STATE OF OHIO
CITY OF CANTON
STA-0153-01.70
MAHONING ROAD NE
ROADWAY IMPROVEMENTS
G.P. 1103

THE PROJECT WORK INVOLVES THE IMPROVEMENT OF APPROXIMATELY 0.67 MILES OF MAHONING ROAD NE, S.R. 153 BETWEEN THE GRACE AVENUE NE AND HARMONT AVENUE NE INTERSECTIONS. THE IMPROVEMENTS INCLUDE NEW STORM SEWERS, CURBS, SIDEWALKS, PLANTERS, SIGNAGE, AND STREET LIGHTING.

REVISIONS	DATE	BY
CONSTRUCTION BIDDING SET	4/21/14	GEA
ADDENDUM NO. 1	5/7/14	GEA

PROFILE MISC.

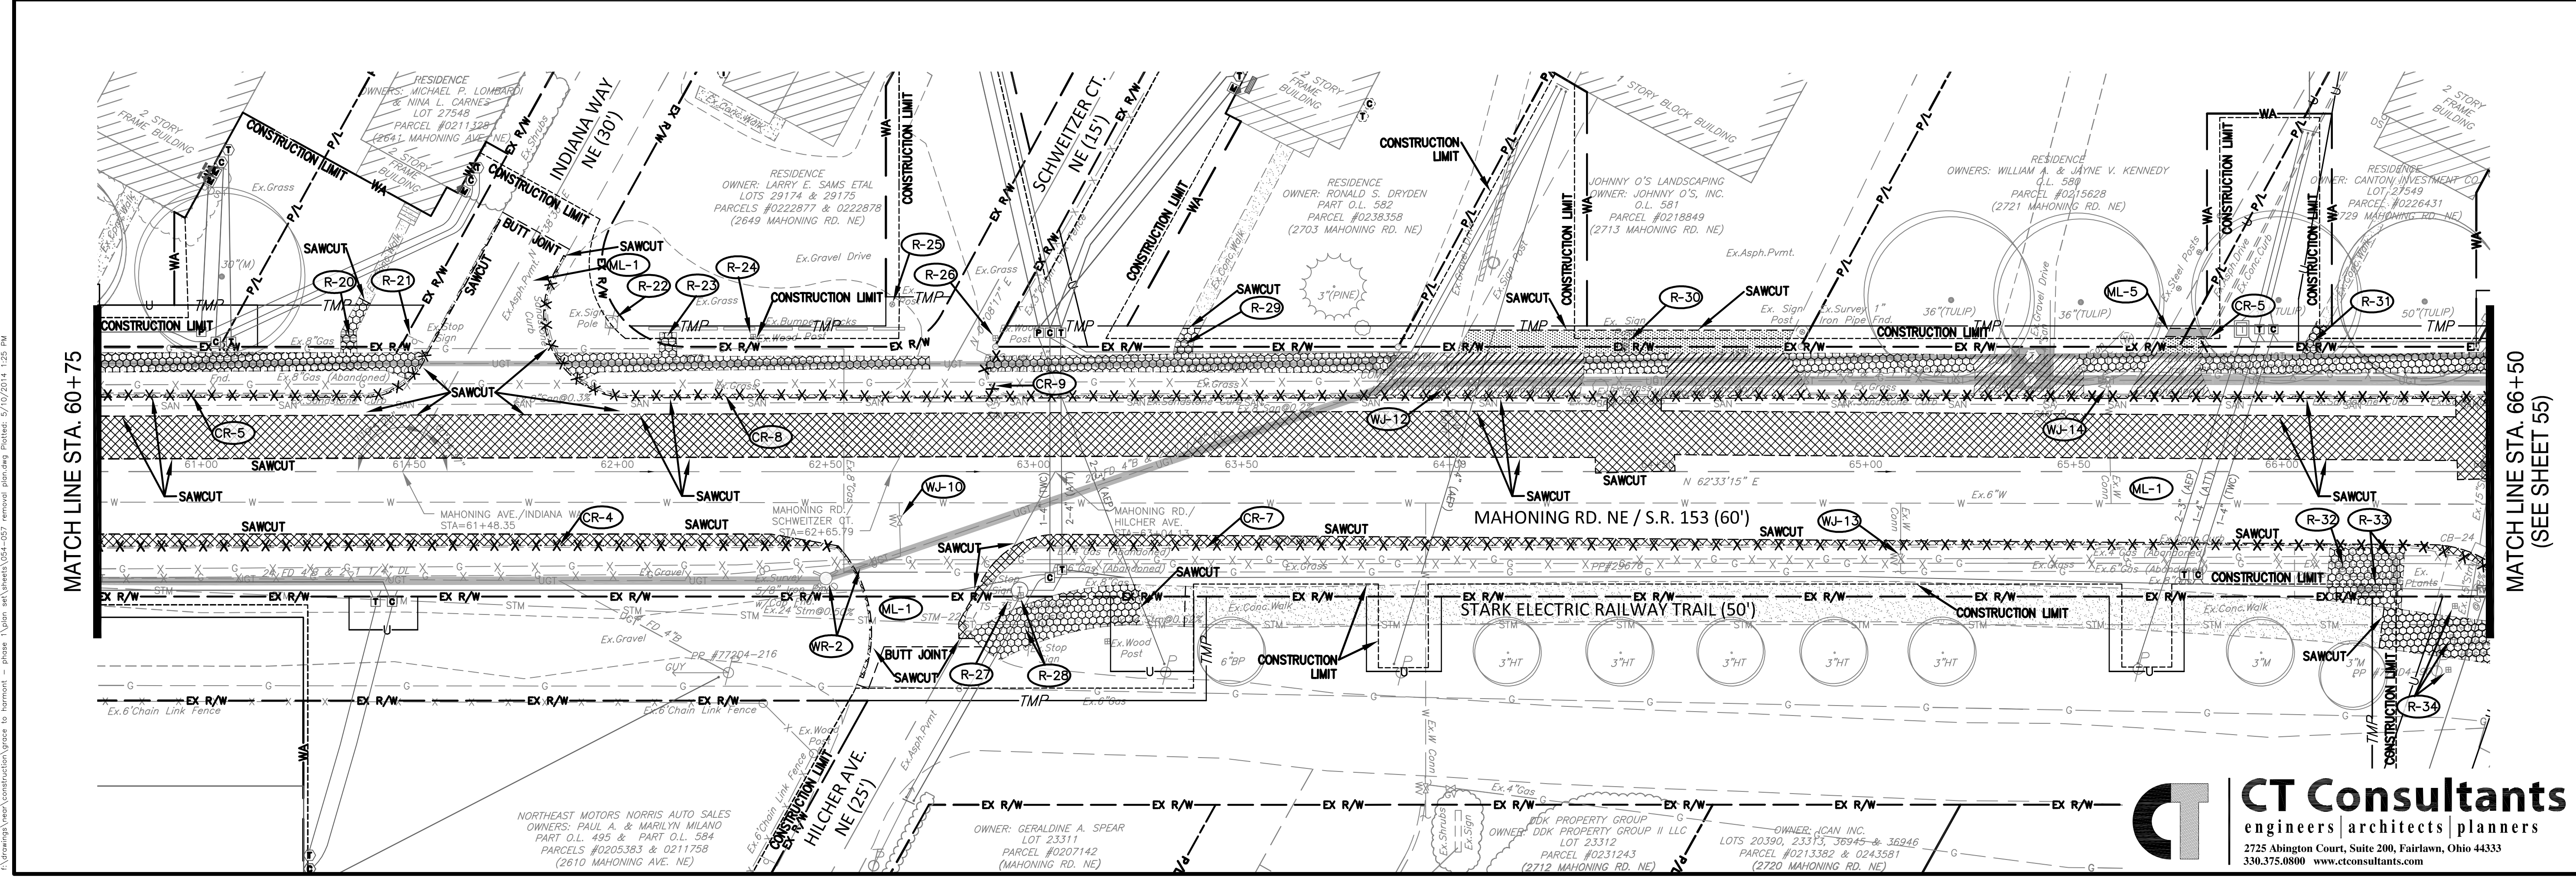
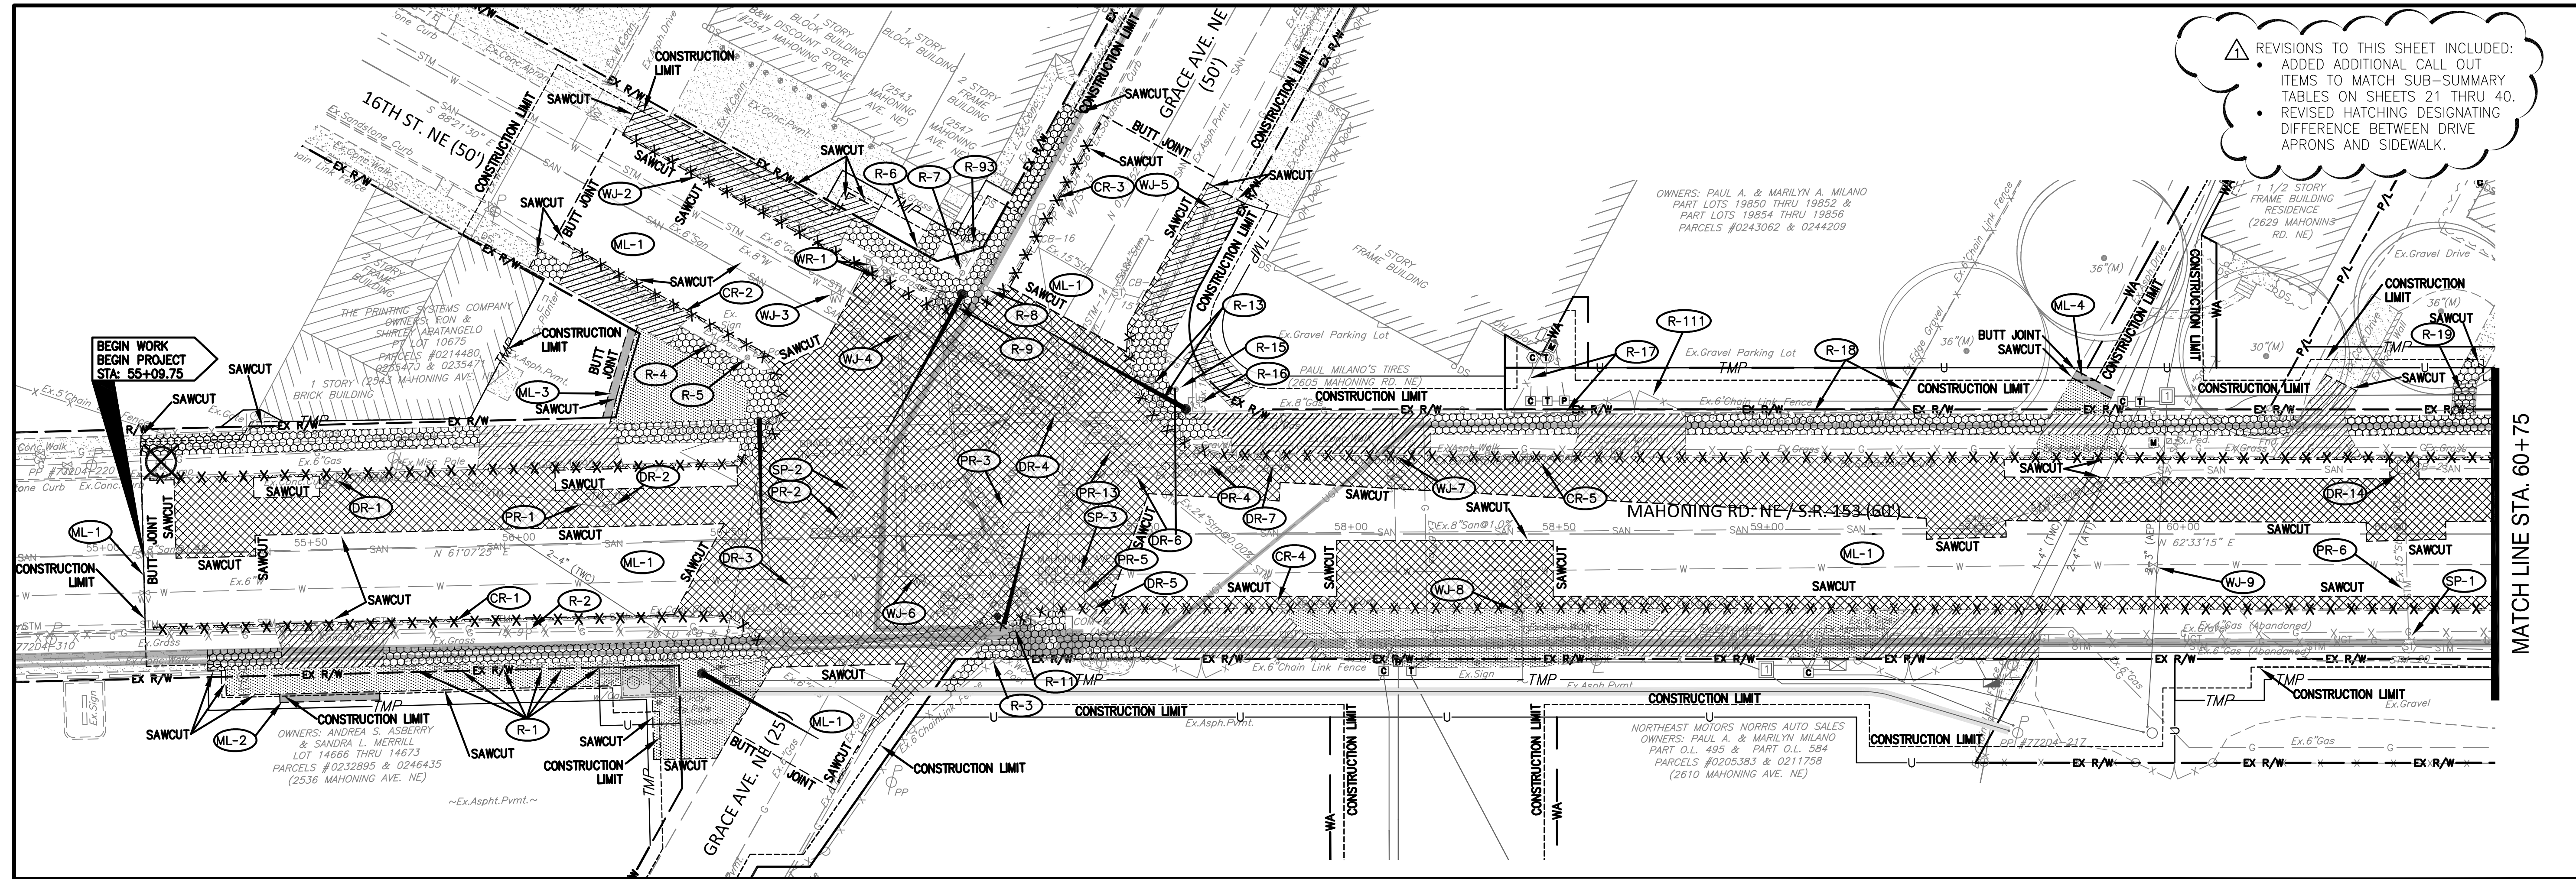
REVISIONS TO THIS SHEET INCLUDED:
 • ADDED ADDITIONAL CALL OUT ITEMS TO MATCH SUB-SUMMARY TABLES ON SHEETS 21 THRU 40.
 • REVISED HATCHING DESIGNATING DIFFERENCE BETWEEN DRIVE APRONS AND SIDEWALK.
